JOHN MOORE HERITAGE SERVICES

**ADDENDUM TO  
BUILDING RECORDING  
ON  
UPPER PARK FARM,  
BECKLEY, OXFORDSHIRE  
NGR SP 57246 11417**

## **ADDENDUM: UPPER PARK FARM**

This is an addendum to the report produced on Upper Park Farm, and contains a reworking and clarification of points raised by the Conservation Officer for South Oxfordshire District Council. These alterations concern reworking of parts of section 3 and 4 that concern the development of the 16<sup>th</sup> century structure. Observed features have been noted on the following plans (figures 20-21)

Figure 21: Plan of first and second floors

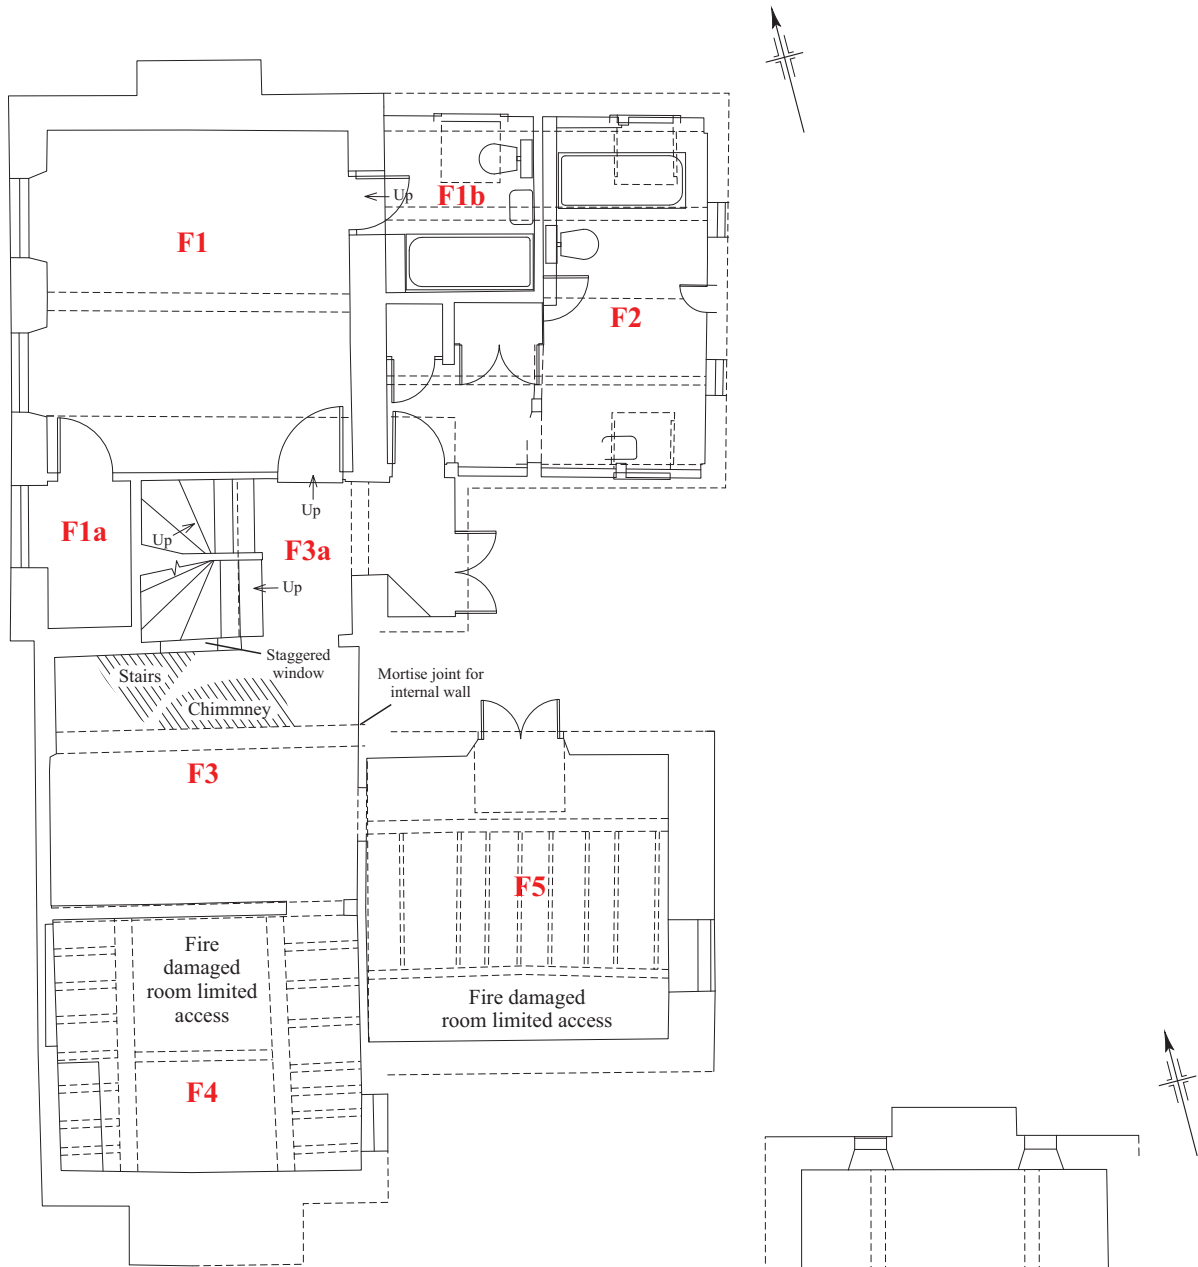
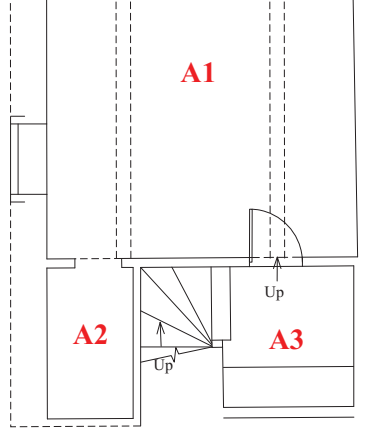
### 3.8 First Floor (Figure 21)

Figure 22: Timber details from rooms G4 and G5

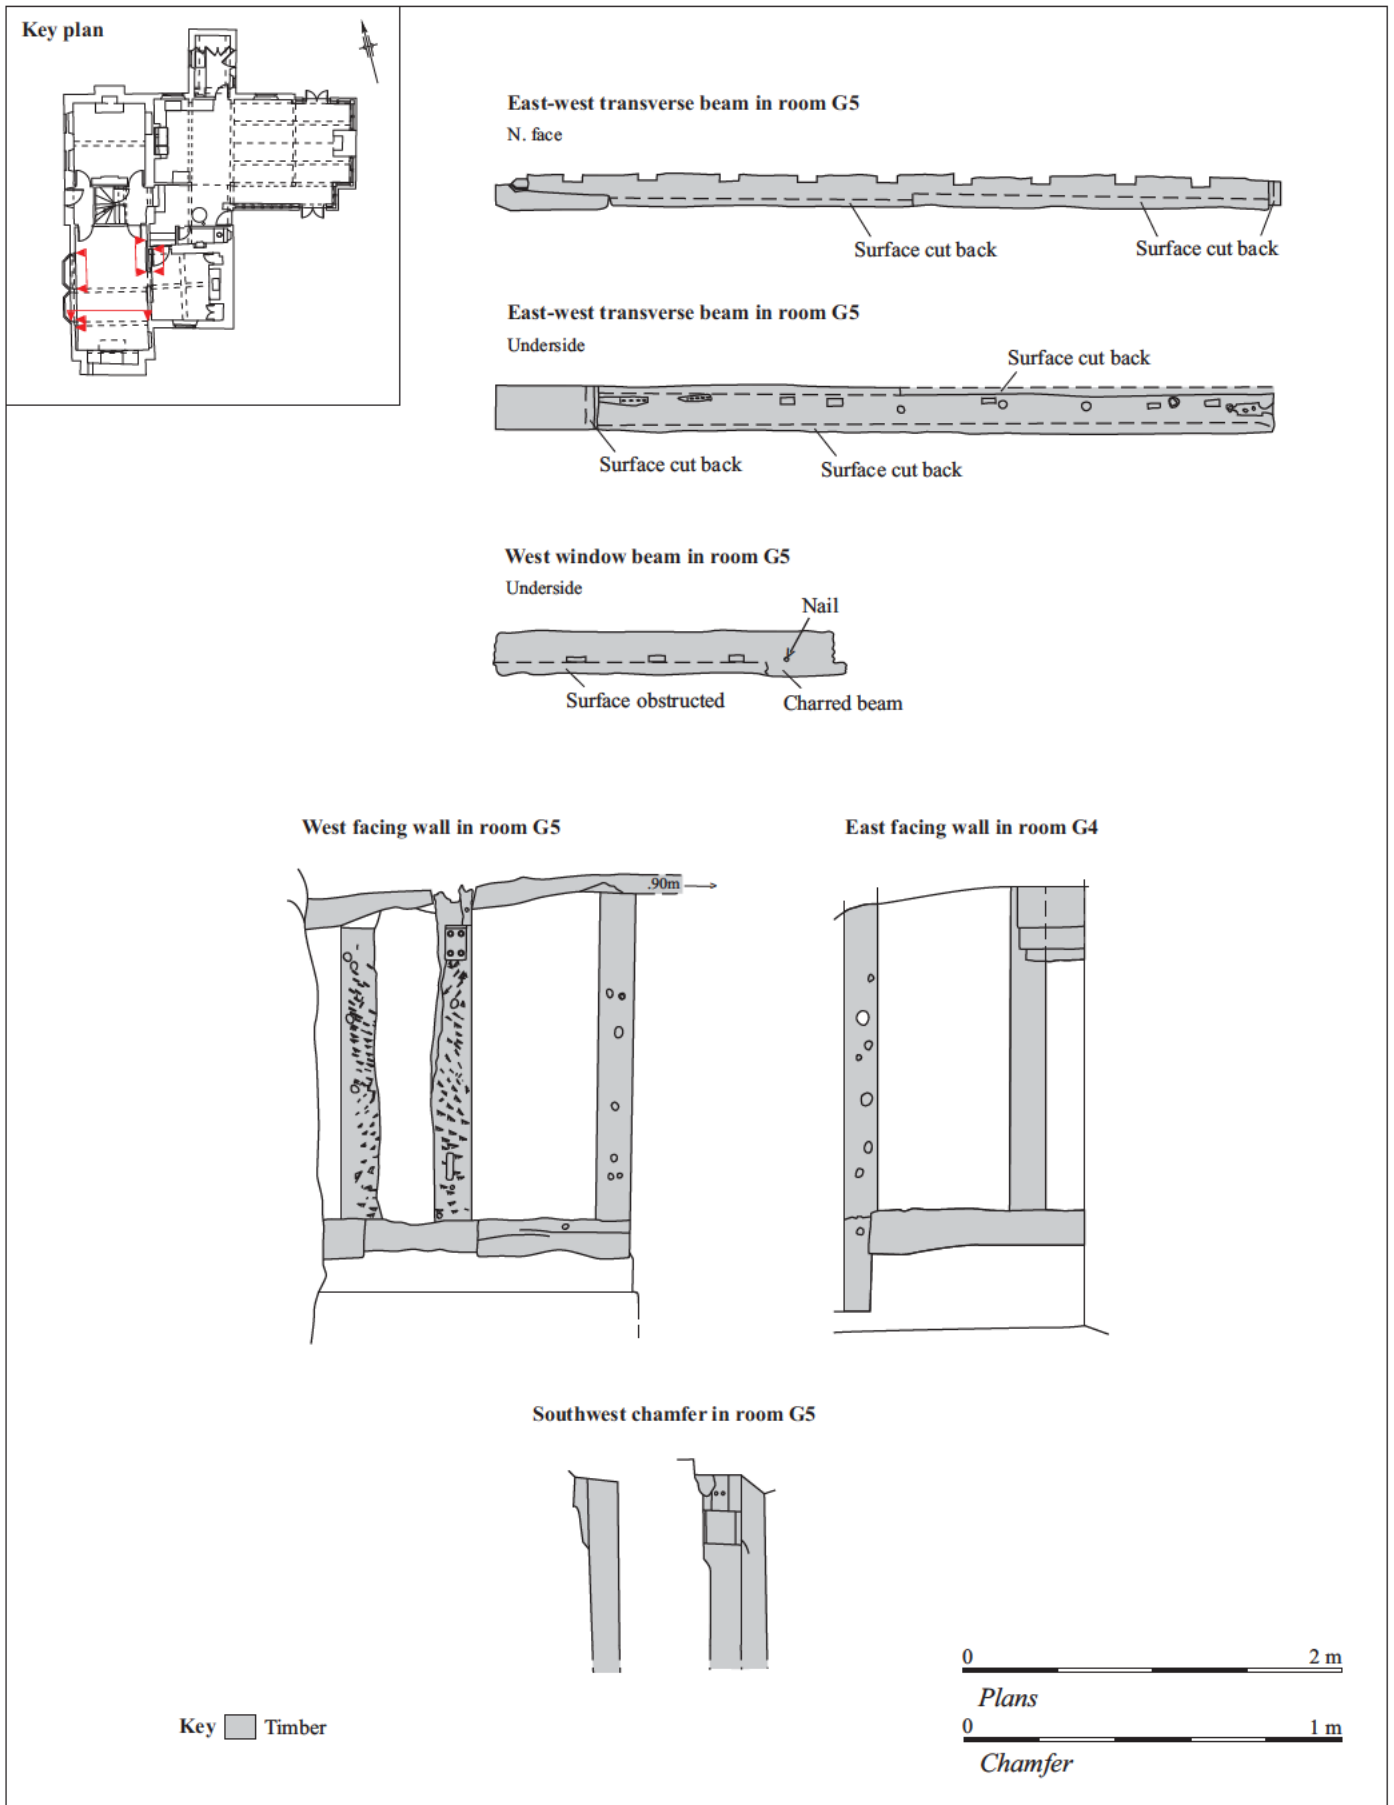
Internally the ground floor room that requires to be re-discussed is room G5. The east wall of room G5 (internal) contains several exposed timbers consisting of four common studs, and a sill beam (Figure 22, plates 44-45). The sill beam has an area cut out towards its northern end as though it was designed to fit around an earlier feature. Two of the stud posts align on the inside of this niche. The south stud here has a mortise joint indicative of

The south window has suffered the least fire damage. The arcade post on the south side has a vertical cut on the top of the north edge measuring approximately 1m in length (figure 22, plates 46-47). This is the remains of a splay for part of a window, for which further evidence is exposed in the horizontal beam above the window.

The southern transverse beam is chamfered with one stop on the south side. The western post has a corbel, supporting the transverse beam (figure 22, plate 51). There is a historic wrought iron L-tie (no date), three iron pins are inserted to the underside of the transverse beam connecting into the corbel, probably to stop the beam failing and provide extra support. There are a number of mortise cuts into the beam that appear to indicate an earlier wall or screen inserted under this beam. At the eastern end of the transverse beam there are historic repairs to the beam using two scarf joints, a newer section extends from the wall providing support where the beam has rotted. A stone wall supports the east end.
